**KANSAS DEPARTMENT OF AGRICULTURE**  
**Division of Water Resources**

**RE:** Application, File Nos. 50,627

# **Technical Report of Source of Supply for Application 50,627 and Safe Yield**

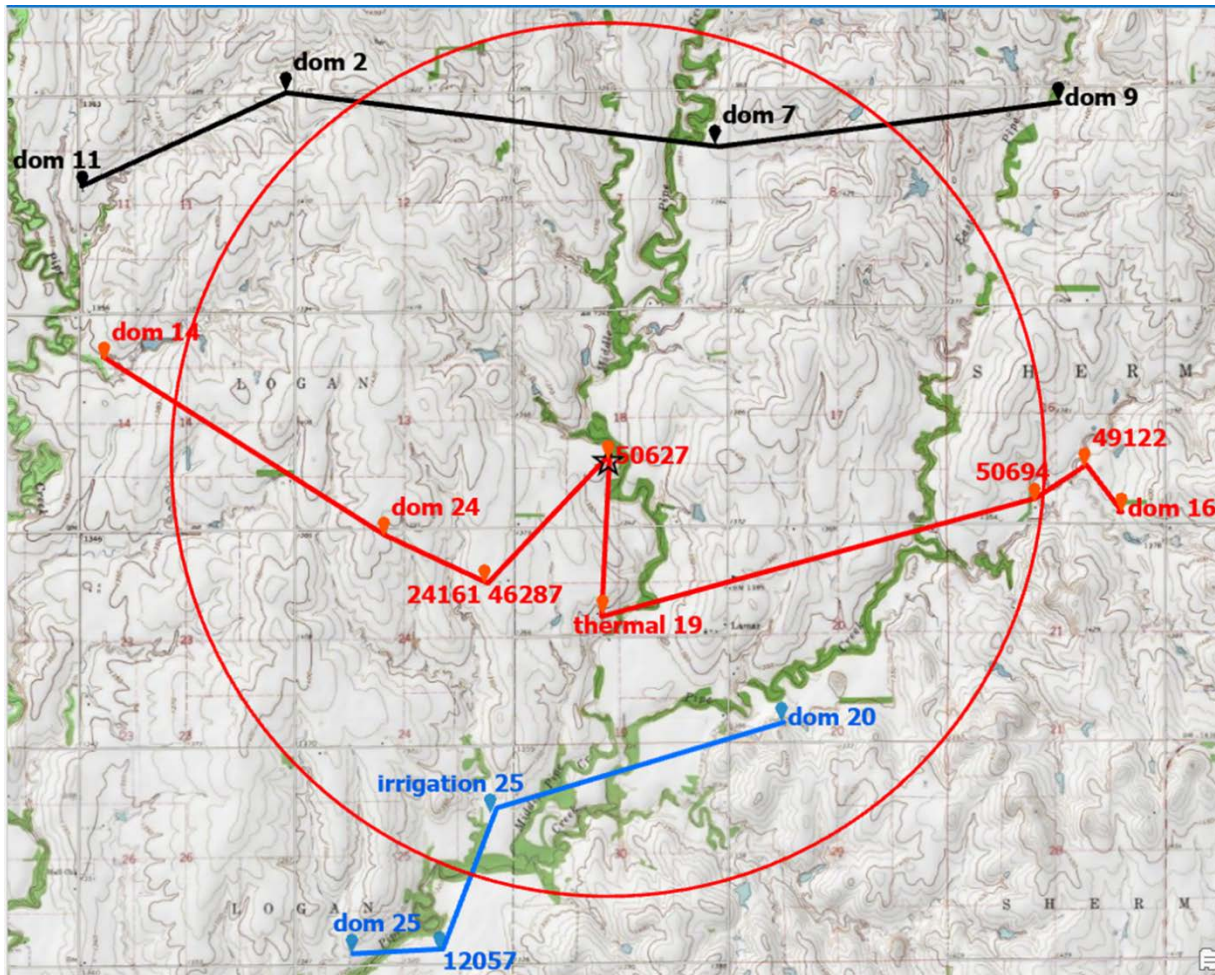
point of diversion across the 2-mile area were plotted on a topographic map from left to right and connected by a black line. Locations from west to east that include the proposed point of diversion were connected by a red line. Locations to the south mainly along Middle Pipe Creek and East Pipe Creek were connected by a blue line. **Figure 2.**

**Figure 3.** Lithologic log plots of well driller logs across the north part of the 2-mile circle of the proposed point of diversion File No. 50,627. Well sites from left to right are connected by a black line from west to east in **Figure 2**.

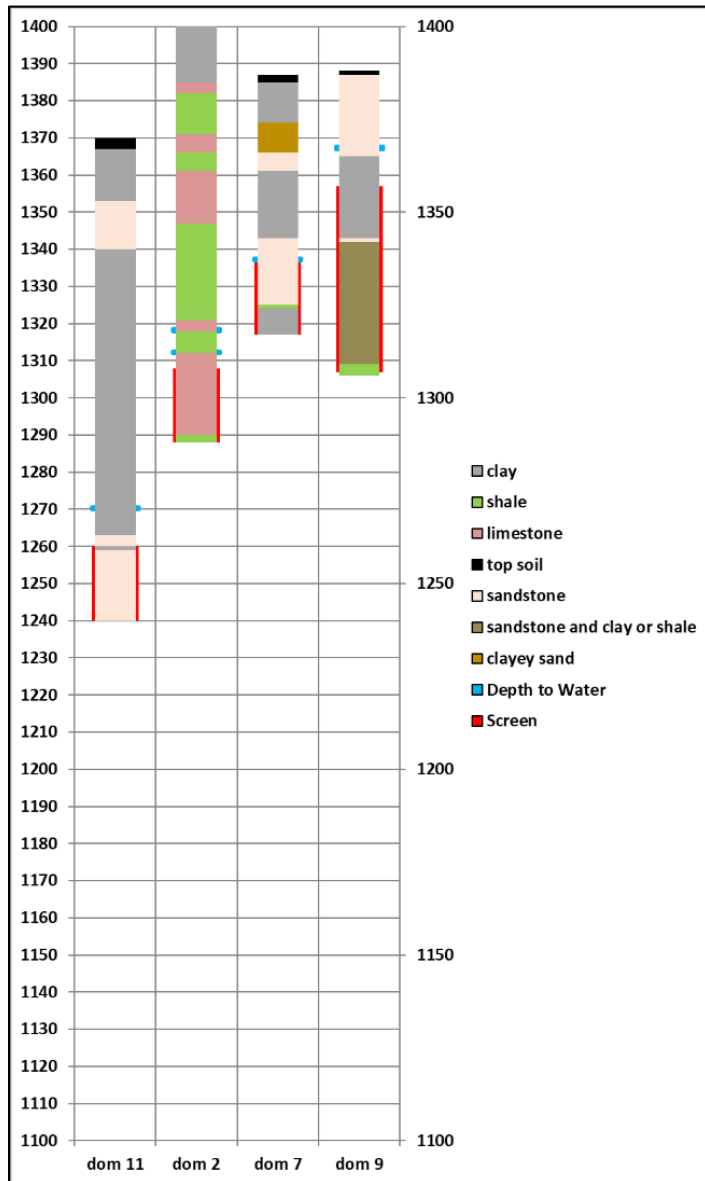
Well driller's logs were plotted in lithologic log charts. Lithologic log plots of wells to the north of the proposed file are connected by a black line in **Figure 2**. The water level in the first log to the far left is in a confining clay. The second log from the left shows the water level in a confining shale. The third log labeled dom 7 is a domestic well along Middle Pipe Creek and shows the water level in a sandstone overlain by clay, then sandstone then an unsaturated clayey sand. The fourth log labeled dom 9 is for a domestic well along East Pipe Creek and the water level appears to be in the top sandstone but water is pumped from deeper sandstone overlain by a confining clay. **Figure 3**.

**Figure 4.** Lithologic log plots of well driller logs to the west, east and near the proposed point of diversion File No. 50,627. Well sites from left to right are connected by a red line from west to east in Figure 2.

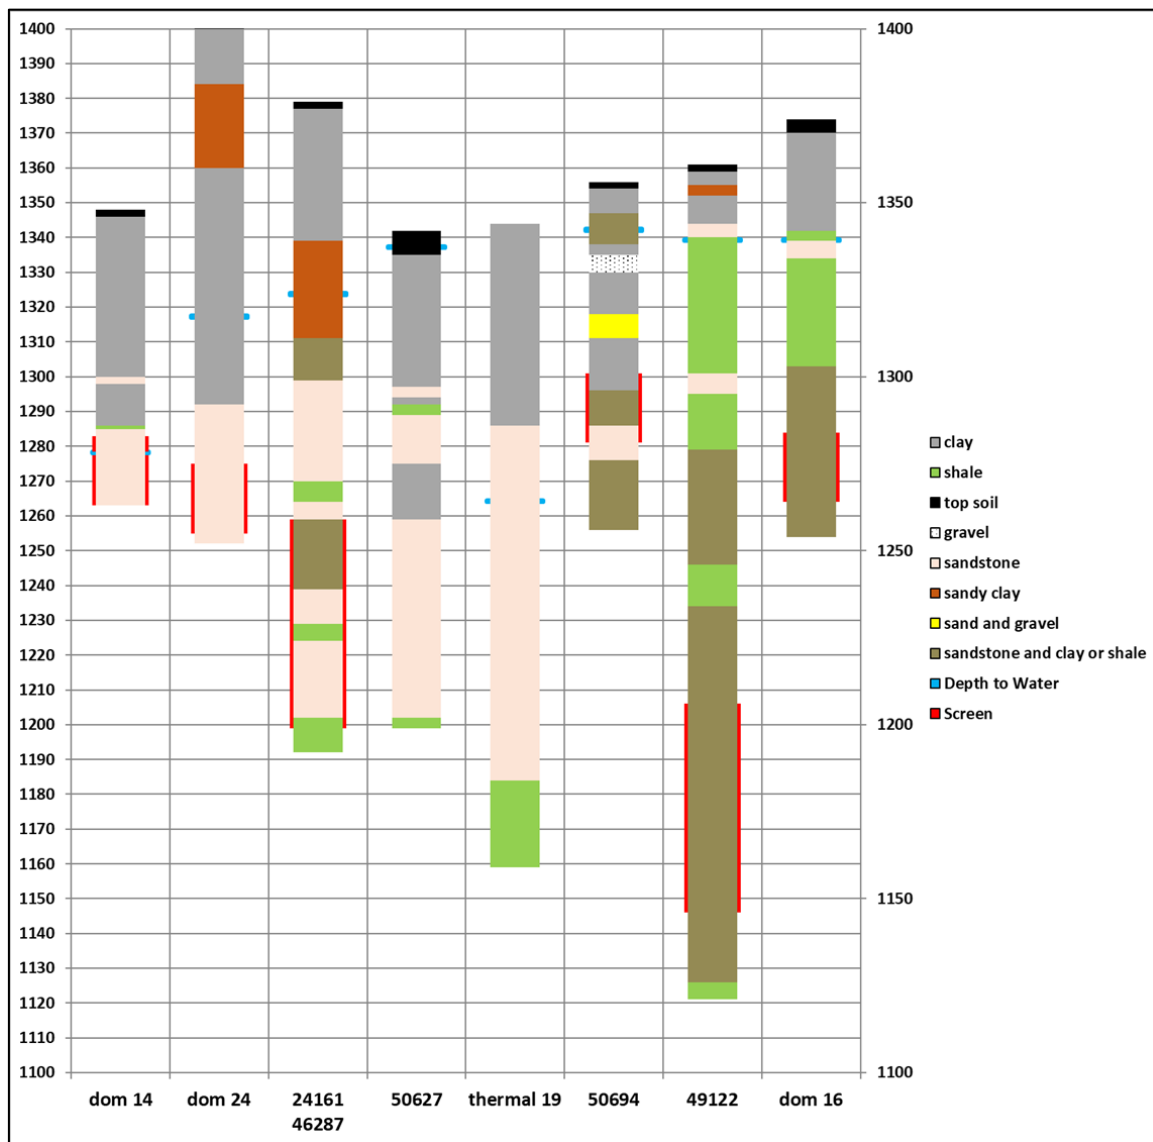
The lithologic log plots to the west, to the east and nearer to the proposed point of diversion are connected by a red line in **Figure 2**. The first log to the far left shows the water level in

a sandstone in the bottom of the well and the sandstone is overlain by confining clay. The second well water level is in a confining clay and the third well for File Nos. 24,161 and 46,287 appears to be in a confining sandy clay. The proposed well File No. 50,627 shows the water level 5 feet from land surface in topsoil or what the driller called dirt. The well log for a thermal exchange well about one mile directly south of the proposed well appears to have the lowest water level than all the others in a deep sandstone overlain by clay. The next two logs for pending junior File No. 50,694 and existing senior File No. 49,122 outside of the 2-mile circle both along a tributary to East Pipe Creek show a shallow water level about the same elevation but the wells pump from deeper sandstones that appear to be confined by clays or shale. The last log to the far right appears to pump from a deep sandstone confined by shale but the water level is about the same elevation as the nearby irrigation well File No. 49,122.

**Figure 5.** Lithologic log plots of well driller logs to the south of the proposed point of diversion File No. 50,627. Well sites from left to right are connected by a blue line from southwest to northeast along Middle Pipe Creek and East Pipe Creek in Figure 2.

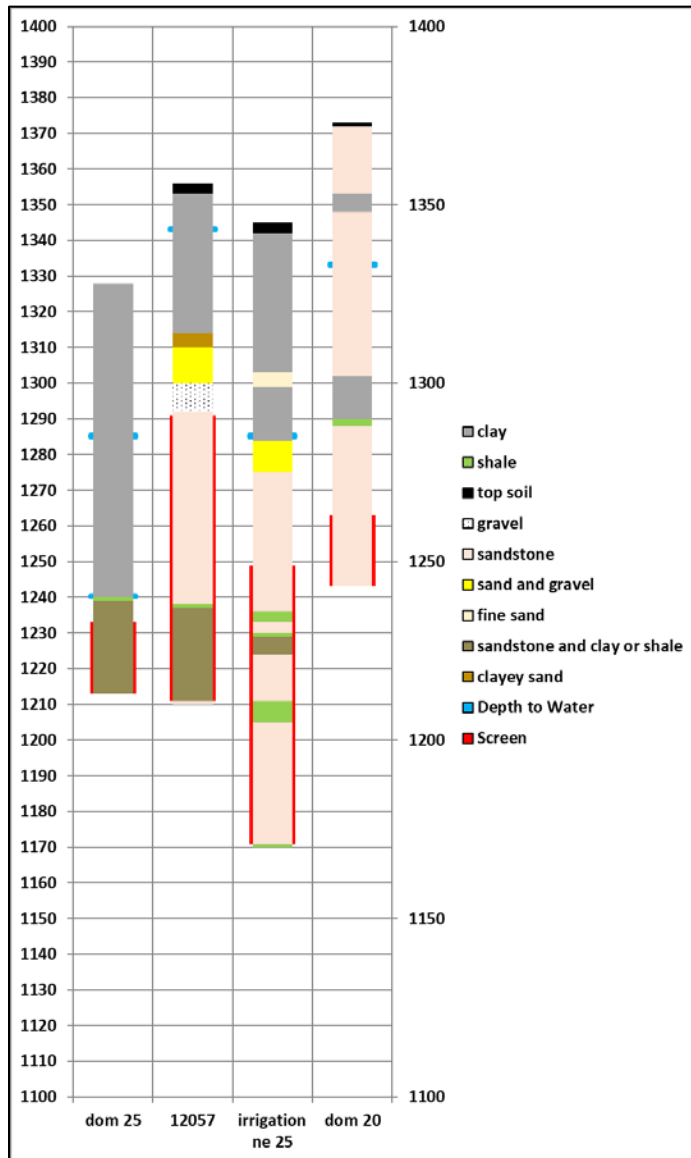
I just noticed that Figure 5 of the report I previously just sent about File No. 50,627 was missing the legend so I revised the report and attached it to this note. I did not rename the file so you probably cannot open it without closing or deleting the other file. Sorry for the confusion but if you are looking at it closely you might want the legend.

Lithologic log plots to the south of the proposed point of diversion connected by a blue line in **Figure 2** are near Middle Pipe Creek and East Pipe Creek. The first log labeled dom 25 is a domestic well pumping from a deep sandstone with clay overlain by an extensive clay confining layer. The second log from the left is for File No. 12,057 for a well screened all in sandstone overlain by gravel and sand and gravel with a shallow depth to water of 13 feet in and extensive clay along Middle Pipe Creek. The next log is for an irrigation well in the northeast of Section 25 along Middle Pipe Creek and is screened in sandstone and shale layers overlain by sand and gravel but the water level deep and appears to be confined by a clay layer. The well log to the far right shows screen in a deep sandstone confined by a clay with the water level in an extensive sandstone between two clay layers. **Figure 5.**

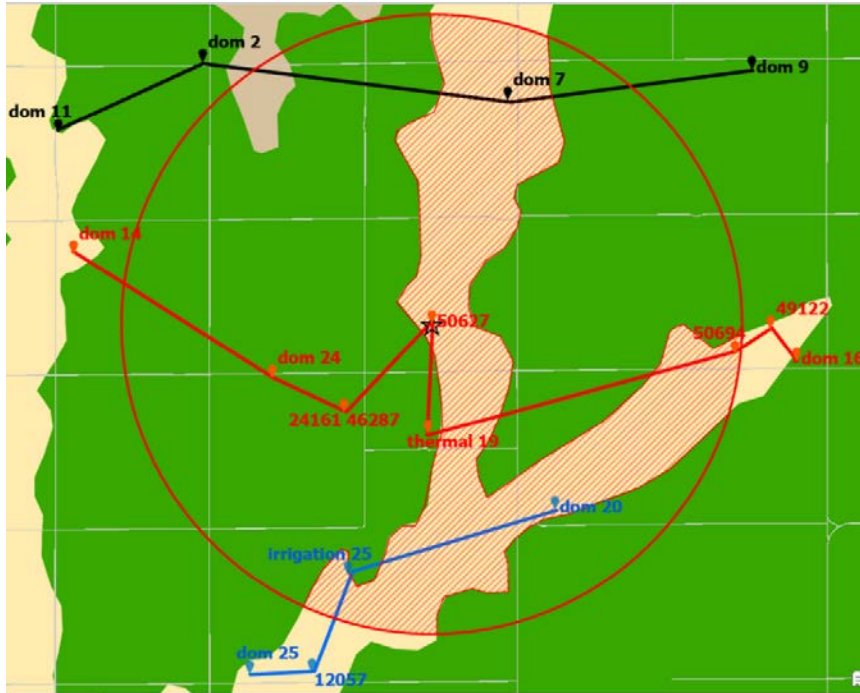
Assuming all 8,042 acres in the 2-mile circle is recharged at 2.6 inches per year and 75% of that is for appropriation of water, there could be as much as 1,306 acre-feet appropriated in the 2-mile circle to meet safe yield. At the present time there is only one well authorized for a total of 108 acre-feet appropriated for File Nos. 24,161 and 46,287. General geologic mapping in ArcGIS Pro used for appropriation suggests the 2-mile circle area is underlain by unconfined Dakota aquifer but about 2,096 acres of the area is overlain by Quaternary deposits along Middle Pipe Creek and East Pipe Creek. While proposed File No. 50,627 proposes to pump from the Dakota aquifer it is in this area where Quaternary deposits interconnect with those creeks. Appropriating 75 % of 2.6 inches in the 2,096 acres of the area overlain by Quaternary deposits would be a safe yield of 340 acre-feet and File No. 50,627 is requesting 156.6 acre-feet. Since there are no other prior appropriations of water in the portion of the 2-mile circle overlain by Quaternary deposits, then water is available for appropriation of water for File No. 50,627. While File No. 12,057 is a senior appropriation of water in the Quaternary deposit area it is outside of the 2-mile area of consideration. File Nos. 50,694 and 49,122 located to the east about 2 miles are in the area overlain by Quaternary deposits but File No. 50,694 is a junior unapproved pending application and senior water right File No. 49,122 is outside of the 2-mile area of consideration.

Well driller's logs from the portion of the 2-mile circle not overlain by alluvial or Quaternary deposits indicate that many of the wells pump from confined Dakota aquifer overlain by confining shale or clay. In areas of confined Dakota aquifer 40% of the standard recharge on average can be appropriated. In this area there are 5,946 acres of Dakota aquifer not overlain by alluvial or Quaternary deposits in the 2-mile circle. At 40% of the standard recharge of 75% of 2.6 inches per year within the 5,946 acre the safe yield in the confined Dakota aquifer would be 386 acre-feet. There is presently 108 acre-feet of water appropriated to the well in the confined Dakota area leaving some water still available for appropriation. **Figure 6.**

The selected PD is in an area OPEN to new appropriations.  
 The safe yield based on the variables listed below is 340.56 AF.  
 Total prior appropriations in the circle 0.00 AF.  
 Total quantity of water available for appropriation is 340.56 AF.

The area used for the analysis is set at 2,096 acres.  
 The potential annual recharge at the circle center is estimated to be 2.6 inches.  
 The percent of recharge available for appropriation is 75%.
